Attachment 2
to ULNRC-06108
April 3, 2014

Attachment 2: Page 1 of 7
Our ref: LTR-RIAM-14-23,
Revision 1
March 28, 2014

Attachment 2
Westinghouse Final Response to U.S. NRC RAI 3.1.2.1-6 (a) and (b) on the Callaway
Nuclear Plant Reactor Lower Radial Support Clevis Insert Bolts (Non-Proprietary)

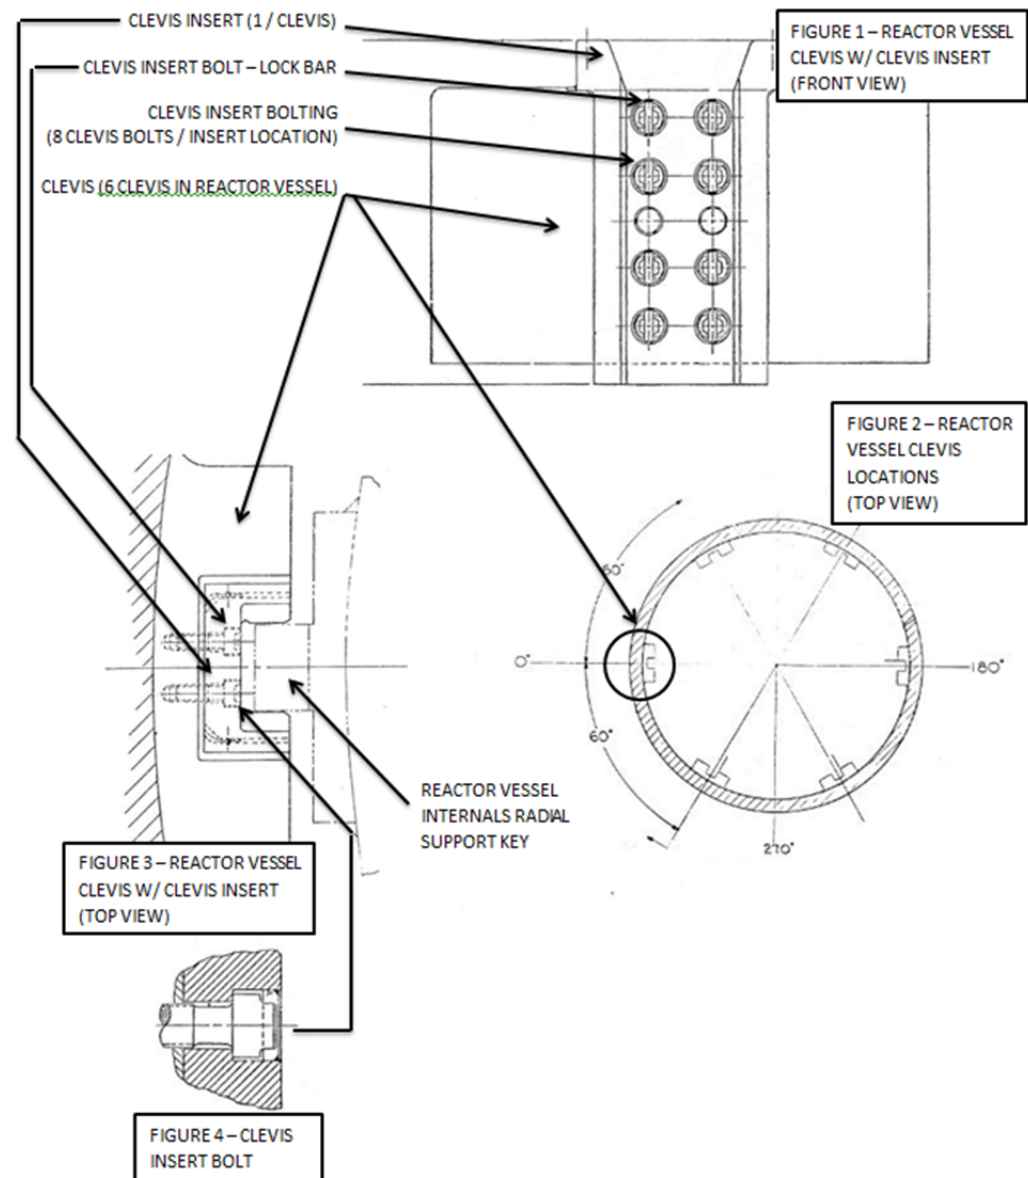
- a) Describe the configuration of clevis insert assemblies at Callaway Plant, Unit 1 (Callaway) including number of bolts in the assemblies. Specify the material of fabrication, including any applicable heat treatment, that were used for the design of the clevis insert bolts at Callaway.
- b) Discuss and justify whether the operating experience associated with cracking of the clevis insert bolts is applicable to clevis insert assembly designs at Callaway.

- a) The clevis insert assemblies at Callaway are comprised of eight clevis insert cap screws fabricated from Inconel X-750, 2 dowel pins fabricated from Alloy 600 and an Alloy 600 hard-faced insert assembly that rests onto the clevis locations in the reactor vessel. In total there are six clevis locations (0, 60, 120, 180, 240, 300 degree locations). The clevis insert cap screws include a lock bar that is welded to the clevis insert face. The clevis insert cap screws are attached to the interior face of the clevis insert assembly.

The Callaway material used for the clevis insert cap screws is the same as used at the reference plant where cracking has been observed. The clevis insert design however is different than the reference plant in that the cap screw locations are included on the interior face of the clevis (parallel to the outside face of the radial insert key with the core barrel installed). This geometry is further defined in Figures 1-4 identified below.

The same number of eight cap screws is arranged in the same two vertical columns of four cap screws each. Two interference-fit dowel pins of the same size are located in-line with the cap screws in the same manner as the reference plant. The main design difference is that the Callaway reactor clevis insert is U-shaped, with the cap screws located inboard of the "U"; whereas the reference plant insert, while also being U-shaped, has flanges on either side where the cap screws are located. The tangential interference fit of the insert against the support lug is at the ends of these flanges for the reference plant design and on the sides of the "U" for the Callaway reactor design. Therefore, the tangential interference-fit compression stiffness of the two inserts is different.
